**MEMPHIS AND SHELBY COUNTY OFFICE OF PLANNING AND
DEVELOPMENT
STAFF REPORT** **#3**

CASE NUMBER: PD 11-313 CC

DEVELOPMENT NAME: Eco2 Development Recycling Center Planned Development

REQUEST: Demolition Landfill

Site Plan Showing Boundaries of Existing and Proposed Demolition Landfills

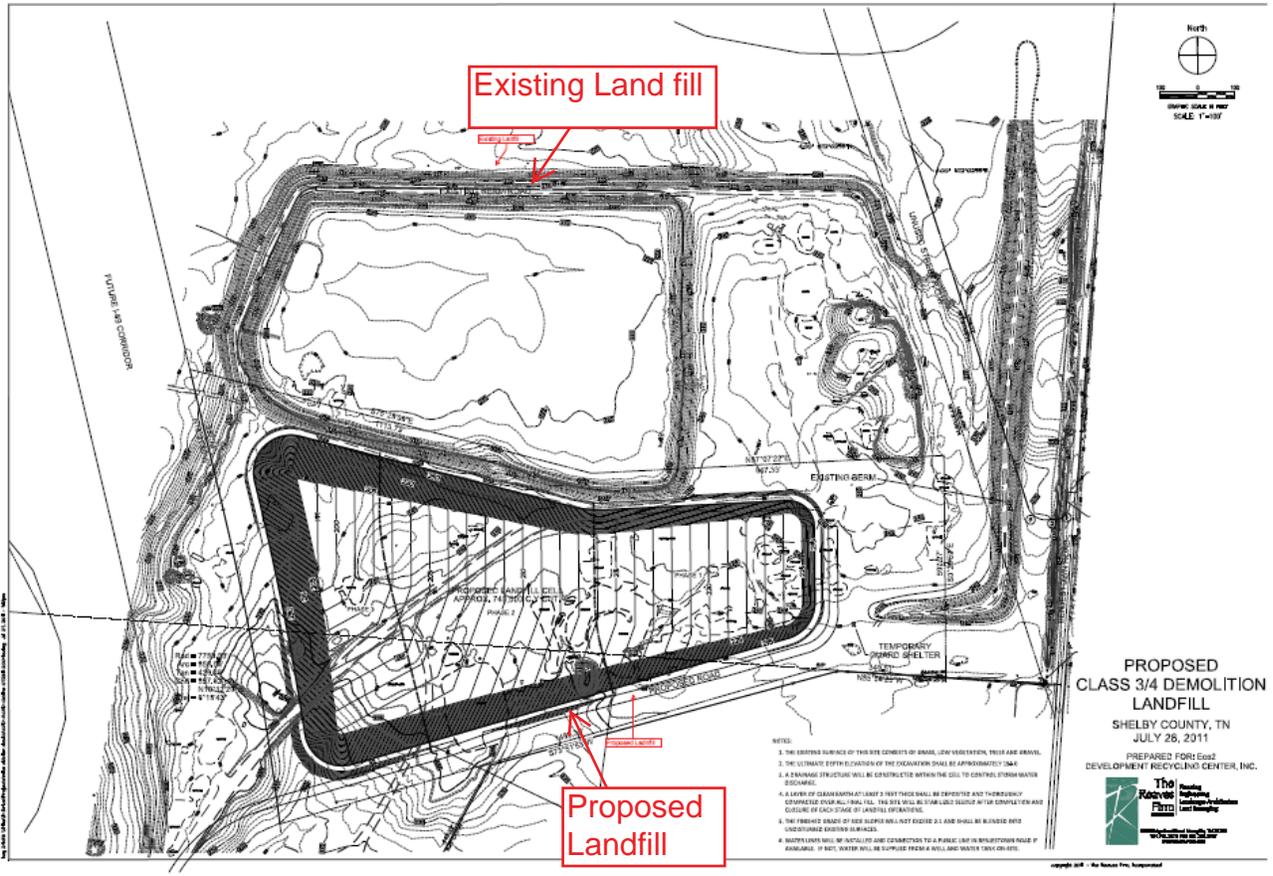
Other changes to the submitted Site Plan - Information regarding the actual right of way width for I-69 has only recently been received. That information indicates that the Tennessee Department of Transportation will require a 350 foot wide right of way for I-69 rather than the 300 feet shown on the site plan and supporting documents. The site plan shall be revised to reflect that change and the resulting change to the landfill area prior to the presentation of this application to the Land Use Control Board.

- E. The site plan shall show the required right of way for I-69.

- F. The site plan shall demonstrate the approved location for the access easement through the I-69 right of way. Documentation from the State of Tennessee may be required at Final Plat Review.
